TECHNICAL BULLETIN

TACHOMETER GENERATOR ASSEMBLY – MODIFICATION KIT PN M50049

The information given in this Service Information Notice lists a procedure, for optional field modification of the N1, N2 and NR tachometer generator installed on the above affected helicopters. The rework kit provides an alternative wiring method in event connector pins on the generator plug cap are broken or damaged, thus permitting continued use of the tach generator in service.

Figure 1. Field rework - tachometer generator inst. Mod. Kit, PN M50449 (sht 1 of 2)

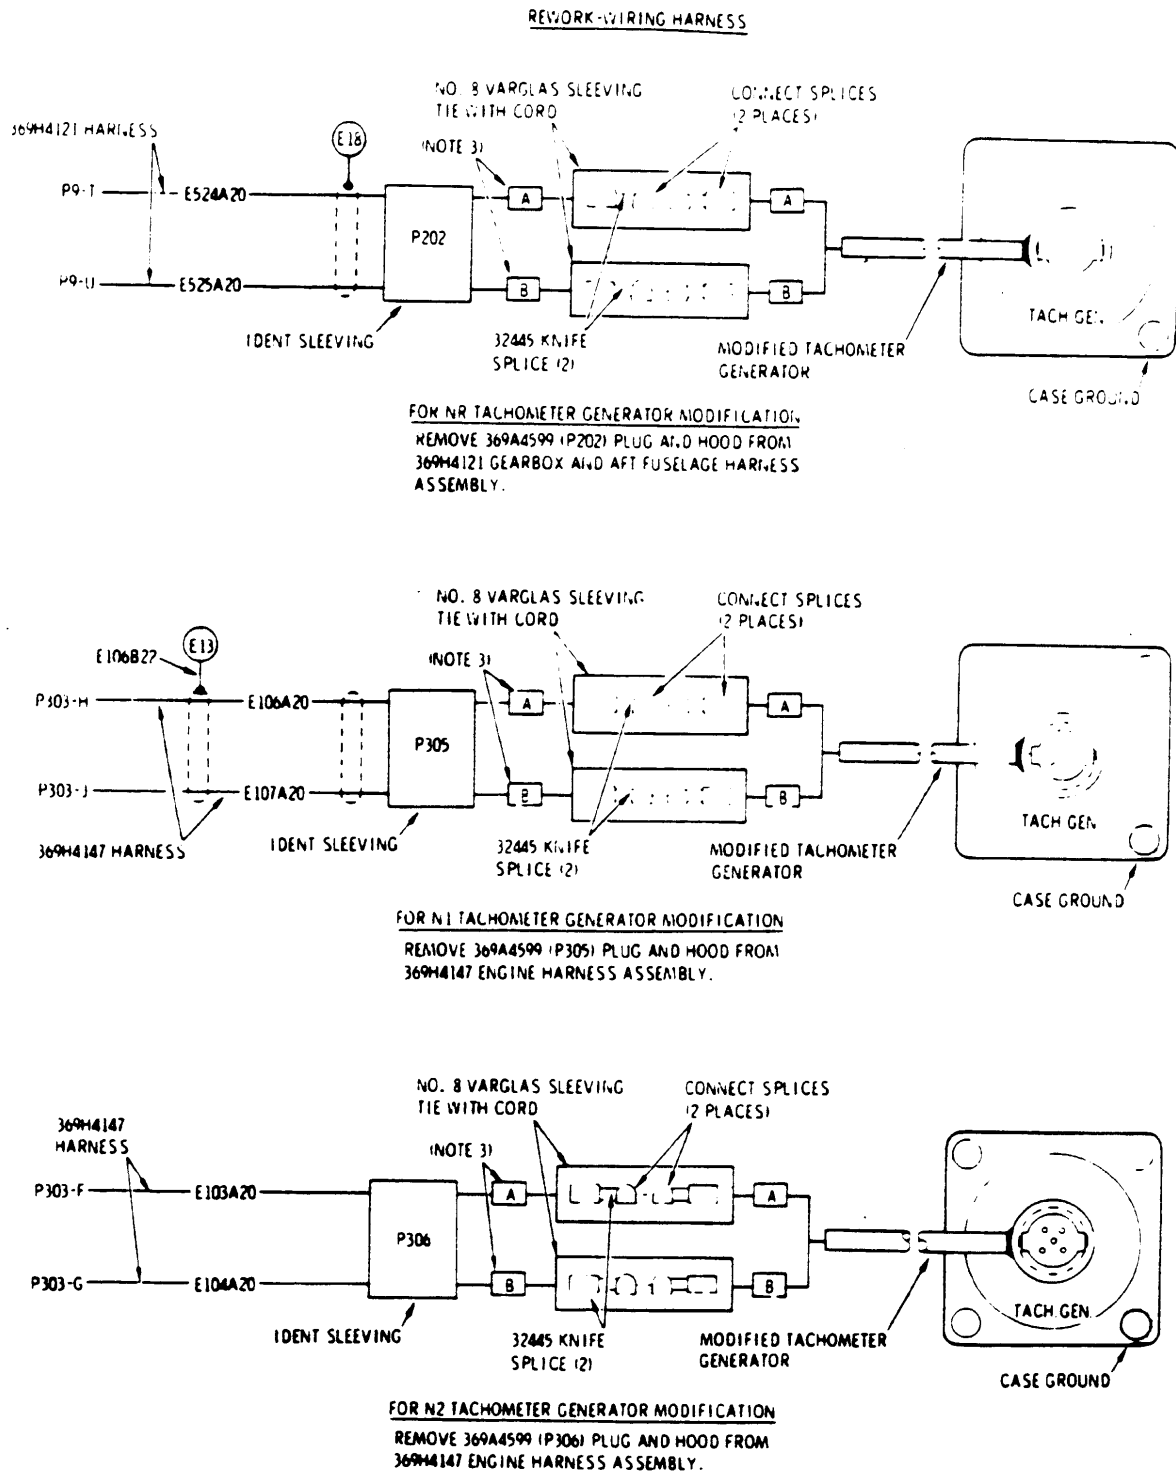
- (2). Remove snap ring securing rear plug cap to generator; disconnect (unsolder) black and white wires from connector pin sockets.
- (3). Cut five connector pins from connector plug, as shown; cover bare metal with adhesive/sealant.
- (4). Drill 0.124/0.129 inch diameter hole in plug cap, per dimensions shown.
- (5). Clean plug area around connector pin sockets with MEK or equivalent.

- (6). Insert assembled M50449 harness wiring through hole in plug cap. Solder wire "A" to remaining portion of Pin A inside of cap; solder wire "B" to remaining portion of Pin B inside of cap.
- (7). Coat area around soldered connections with adhesive/sealant to provide bond for potting compound.
- (8). Fill cavity in plug cap with potting compound; allow to cure for 8 hours minimum.
- (9). Reinstall rear plug cap on generators; secure with snap ring.
- (10). Rework 369H4147 engine wiring harness and 369H4121 gearbox and aft fuselage harness assembly as follows (see Figure 1):
 - (a). Remove 369A4599 plug and hood from wiring harness.
 - (b). Install identification sleeves (A and B), knife splices and Varglas sleeving.
 - (c). Tie Varglas sleeving with cord.

Figure 2. Field rework - tachometer generator inst. Mod. Kit, PN M50449 (sheet 2 of 2)

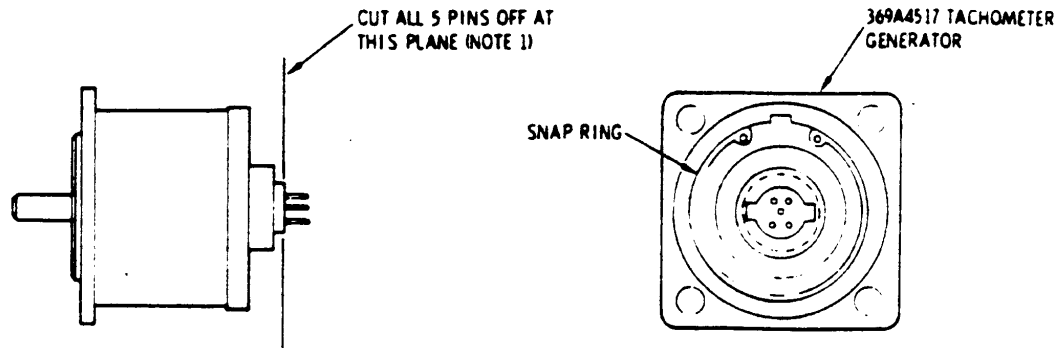
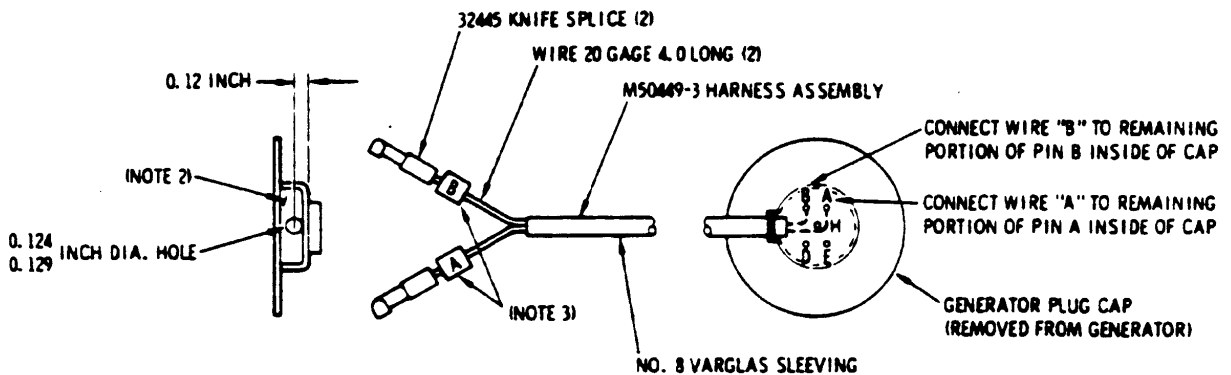
DO NOT REMOVE "ROTOR" FROM GENERATOR HOUSING AT ANY-TIME DURING MODIFICATION.

1. COVER BARE METAL WITH ADHESIVE/SEALANT.
2. FILL CAVITY WITH POTTING COMPOUND AFTER ASSEMBLY OF WIRE AND SLEEVING.
3. IDENTIFY AS SHOWN.
